**Regulation No. 46 (Devices for indirect vision)**

### **Proposal for amendments to Regulation No. 46 (Devices for indirect vision)**

**Submitted by the expert from Germany\***

Figure 6a  
Definition of mirror glass reference direction

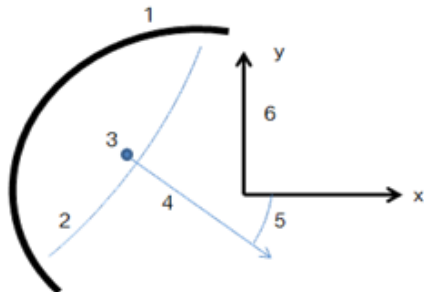
**15.2.4.3.2.3. The mirror glass reference angle is the angle assumed by a projection of the mirror glass normal vector onto the road surface relative to the vehicle-fixed x-axis when the mirror glass is in the reference position.**

**The reference position is the position of the mirror glass that fulfils the required field of vision according to paragraph 15.2.4.3.2. The reference position is defined in the test procedure for granting type approval.**

Figure 6b  
Definition of maximum pivoting direction

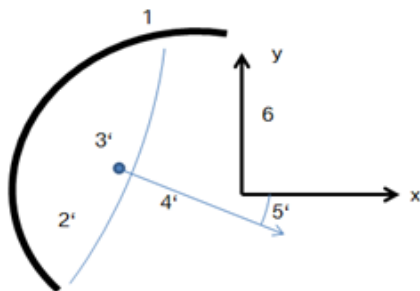
**15.2.4.3.2.4. The maximum pivoting angle is the angle assumed by a projection of the normal vector of the mirror glass onto the road surface relative to the vehicle-fixed x-axis when the mirror glass is in the maximum pivoted position.**

The normal vector of the mirror glass is the vector that runs vertically through the mirror glass surface initiating from the centre of gravity of the mirror glass surface.<sup>1</sup>

Figure 6c  
Maximal permitted difference between reference position and maximum pivoted position

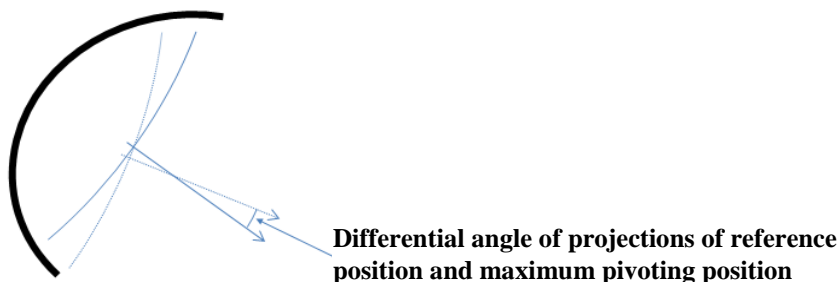
**The difference between the mirror glass reference angle and the maximum pivoting angle shall not exceed 15°. The glass shall only be pivoted in the direction that turns the field of vision away from the vehicle.**

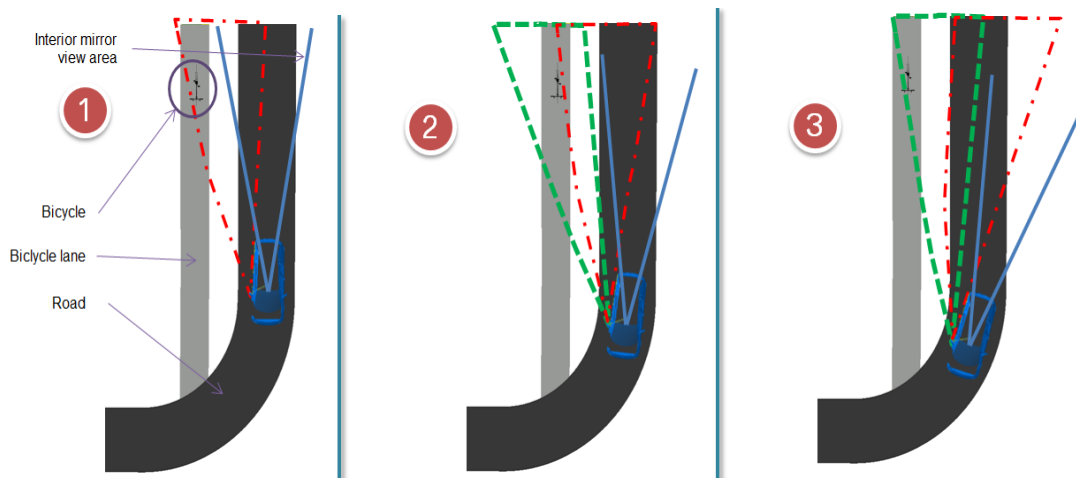
1. The current text of UN Regulation No. 46 allows only mirrors that do not alter the measured field of vision. This restriction restrains the technological progress and could hinder progress in addressing dangerous traffic situations.
2. During a turning manoeuvre, the present mirror design prevents a road user that can be seen in the field of vision of the driver before the turn from being seen during the turning manoeuvre (see figures below).
3. This proposal for an amendment of the Regulation is supposed to contribute to the prevention of such dangerous traffic situations. It is proposed to allow the pivoting of the mirror glass at the passenger side of a vehicle to enable a better field of vision for the driver during turning manoeuvres especially in city-areas compared to the field of vision that can be obtained with conventional mirrors.

Vehicle is just before road curve, about to make a turn.  
Cyclist is visible in exterior rear view mirror on passenger side (red-dotted field of vision)

Vehicle entered road curve, yaw angle 8°. At standard non-pivoting mirrors the cyclist disappears from the field of view of the driver (red). With fully pivoted mirror the cyclist can still be seen however (green). Through mirror pivoting the original field of view remains effective for a longer period.

As from approximately 18° yaw angle the cyclist almost disappears from the field of view despite pivoted mirror (green). Now, a near cyclist who is at risk of a collision can be seen through the side window however. Cyclists yet further away and not directly visible through the side window or in the mirror are no longer affected by the direction of travel of the vehicle.
